INDESIT company

Model type:
WE12SDE

Commercial code:
F027149

FIG. 1

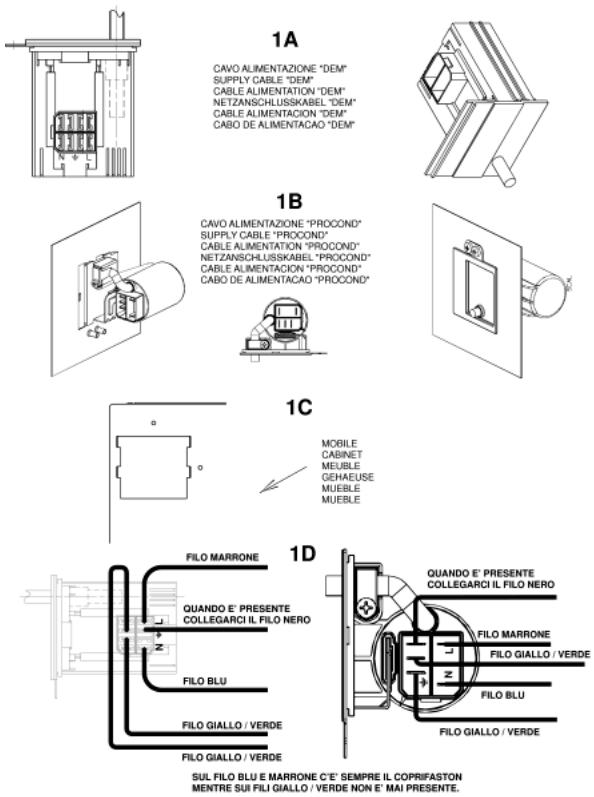
n1040276: Power supply cable + integrally moulded filter.

All appliances produced in the Comunanza (from serial no. 21008.0001), Teverola (from serial no. 21111.0001) and Brembate (from serial no. 21119.0001) factories have been equipped with power supply cables with integrally moulded filter (see fig.1 - 1A and 1B) and new units having a specific opening at the back for fixing the new cables (see fig. 1 - 1C).
The new units, together with the new cables, can be used in place of the premodification ones, by connecting the wiring to the cable, as shown in figure 1 - 1D.
The codes of the new units and of those replaced (ESI - table n1040276fig02), which will be managed until stocks run out, are given below.

The premodification wirings, are also managed for modified products by making the connection to the terminal block of the new cable as shown in fig. 1 - 1D.
The wiring diagrams given in the Documentation remain unchanged.

IMPORTANT: the fixing / continuity screw is a specific self-scraping screw (code 092348) that ensures earth continuity between the filter and the unit. The same screw must be refitted in order to guarantee machine conformity.

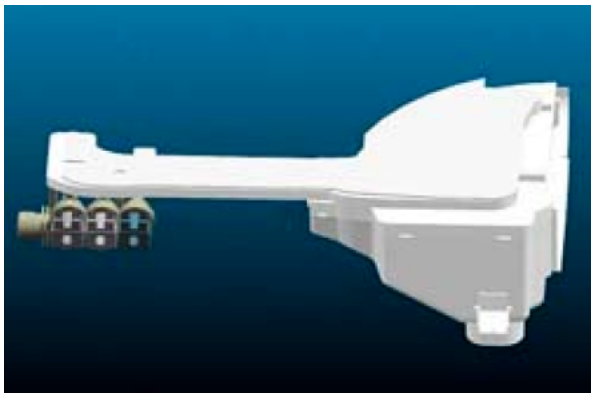
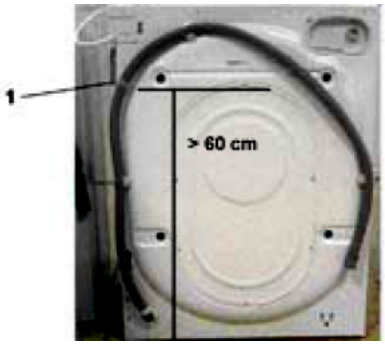
n1040282: New drainage OKO system.

- EEPROM (the OKO system requires a new setting of load timing parameters). THE NEW EEPROMS REPLACE ALL THE ONES CODED PREVIOUSLY.
- BOWL (hopper tube hole shifted forwards);
- DETERGENT LOADING TUBE (see fig. 1);
- PRESSURE SWITCH (changed levels);
- OKO PUMP BOWL BLOWER + BALL (see fig. 2A, 2B and 2C);
- CONDUCTIVITY SENSOR (if provided, it is shorter than the premodification item);
- DRAIN PUMP (without detergent collecting tube connection);
- HOPPER (shifted in front of detergent loading tube connection). Fig. 3A post-modification. Fig. 3B premodification);
- AIR TRAP (different shape);
- PRESSURE SWITCH TUBE (different length);
- DRAIN TUBE STOP (specific);

In particular, the OKO system consists of a spherical plastic component inserted in the tube that connects the bowl to the drain pump (see fig.2 A).
At the beginning of each wash cycle the washing machine fills water for 10 seconds and activates the drain pump for 2 seconds. In this way, the water level in the bowl is different from that in the drain tube; this difference increases the thrust of the ball upwards, closing the bowl-pump connection tube hermetically (see fig. 2D).
This system has the double advantage of:

1) separating the wash water and the water in the drain hose, thus saving energy during the heating phase;
2) and ensuring optimal use of all the detergent.
With the introduction of this new component, the detergent collecting tube is no longer required and the pump has one hole only to convey water from the tank.
For the correct operation of the OKO system, it is important that the drain hose of the washing machine remains fixed to the back of the unit with a plastic clamp (to this end, the clamp withstands a 25 kg load; see reference 1 in fig. 4); otherwise, the drain hose must absolutely reach the height of the clamp. (minimum 60 cm.)

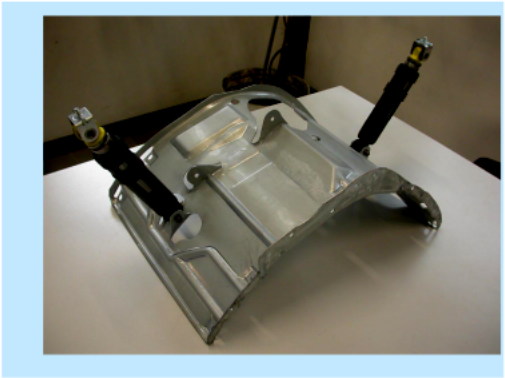
n1040325: New shock absorber fixing system with pin

From serial no. 40427.0001, shock absorbers have been fixed to the tank unit cradle with two 11 mm pins code C00110163 (see fig. 01 and 02 enclosed) in place of the 8 mm screws code 093750 and relevant locking nuts code 030443, on all washing machines and dryers produced in the Comunanza factory.
The items affected by this modification are:

2) The new shock absorbers, with fixing bushing having no s/steel spacer, are not managed as they are interchangeable with the premodified items (make sure they are CIMA type, as the managed items), fixed with M8 screws code 093750 and related locking nut code 030443 (see figs. 05 and 06).
Code 093884 - Shock absorber 80 N
Code 093885 - Shock absorber 100 N

To remove the shock absorber from the tank, first extract the pin with a few hammer taps (see fig.03) until it is aligned with the tank bracket and then pull it out with a pair of pliers (see fig. 04).
(To refit the shock absorber use a new pin. Insert the pin until the toroidal edge is aligned with the bracket.)
